RE: **Docket No. 20-035-24**  
In the Matter of the Formal Complaint of Scott Macdonald against Rocky Mountain  
Power  
*Response to Request for Supplemental Information*

In accordance with the Order Denying Motion to Dismiss and for Supplemental Information issued by the Public Service Commission of Utah (“Commission”) on August 5, 2020, in this docket, PacifiCorp (“the Company”) respectfully submits its written response to the Commission’s questions.

Figure 1 -  $P_{st}$  Level at Wheelon Substation

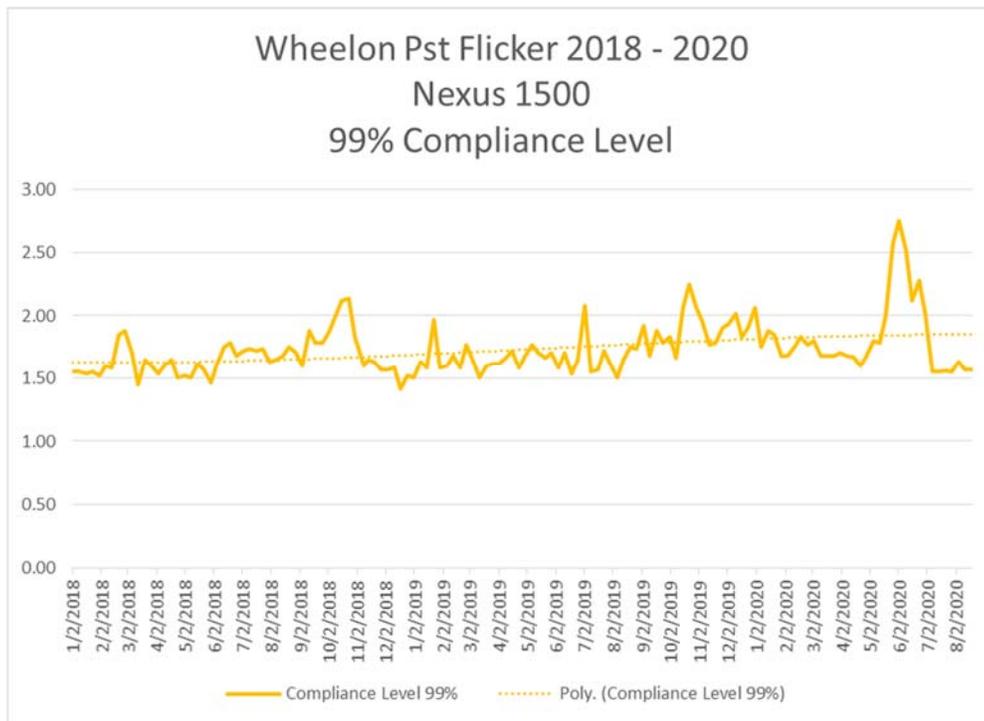
**RMP’s Motion indicates it is “aware of increased flicker measurements on its distribution system in the vicinity of [Complainant’s] home.” Please provide the measurements to which RMP refers and explain their source.**

Rocky Mountain Power has been monitoring flicker at a substation that is considered the point of common coupling for a large fluctuating load [REDACTED] in the area (“Large Customer”). Rocky Mountain Power has been working with the Large Customer to bring the amount of light flicker caused by their operations to within levels compliant with IEEE 1453. The flicker values have been recorded by a Nexus 1500 power quality monitor that determines  $P_{st}$  using the IEEE 1453 computation method (see figures 1 and 2.)
